DRB MEETING

Tuesday, August 06, 2024 at 7:00 PM

Final Plat Application Application # FP 002-24

**FINAL PLAT REVIEW
Two-Lot Minor Subdivision
FP-002-24**

2. **Site plans.** Applicant has submitted a site plan titled “Total Station Survey- Portions of Lands Owned by The Estate of Pauline Nye- Lot 2” prepared by Brad Ruderman & Associates, Inc. dated 6/26/2024.
 - i. The proposed property lines
 - ii. The proposed boundaries for Lot 1 and Lot 2

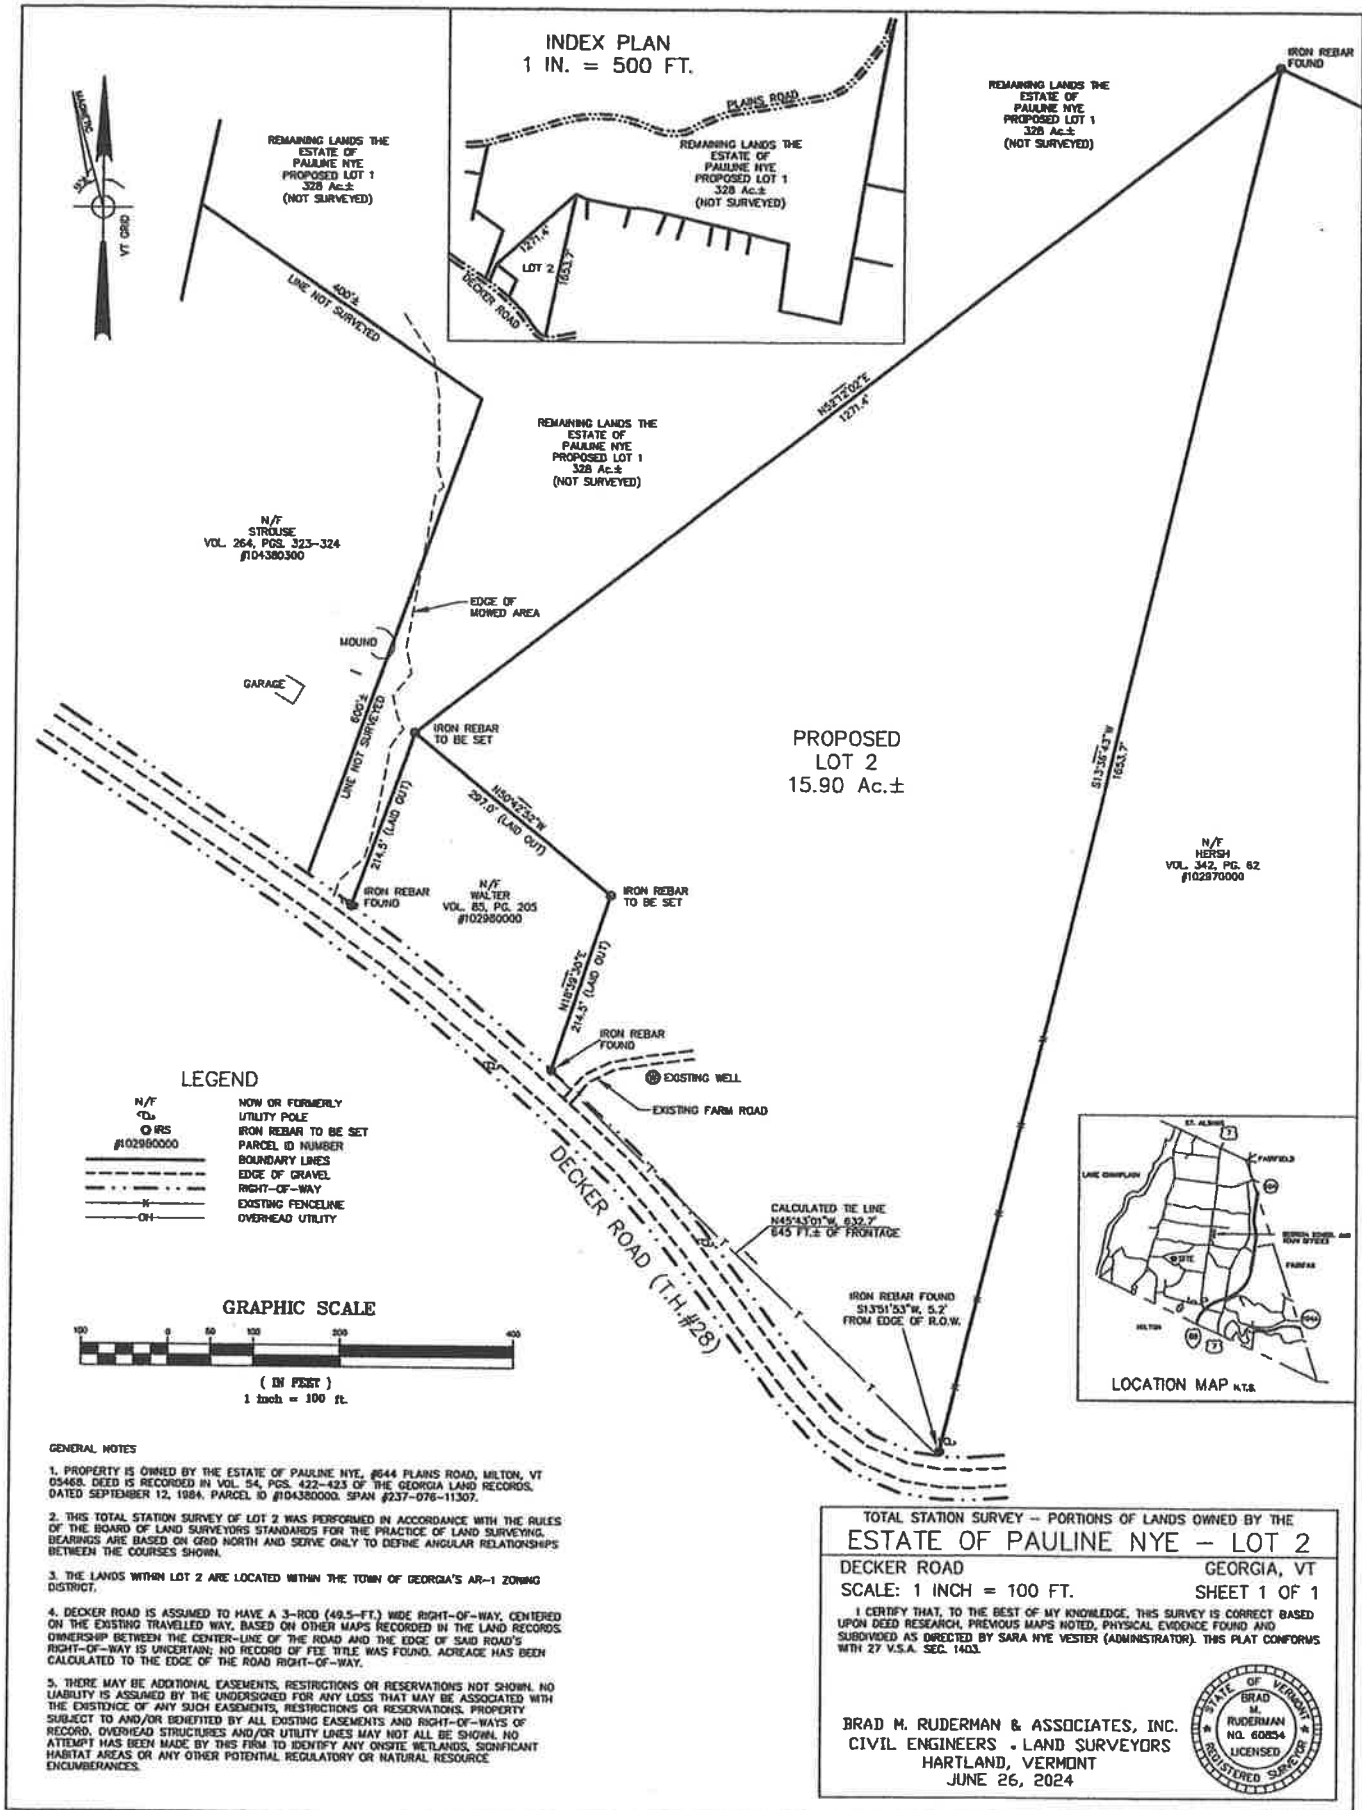
- iii. The location of existing well
 - iv. The location of existing farm road
 - v. Locations of iron rebars found
3. **Lot layout.** As proposed, the boundary lines are linear and proposed lots are generally regular in shape.

4. **The land is suitable for subdivision or development.** The land meets the requirements for the subdivision with road frontage and acreage. The parcel is vacant land and will remain vacant land after subdivision of property.
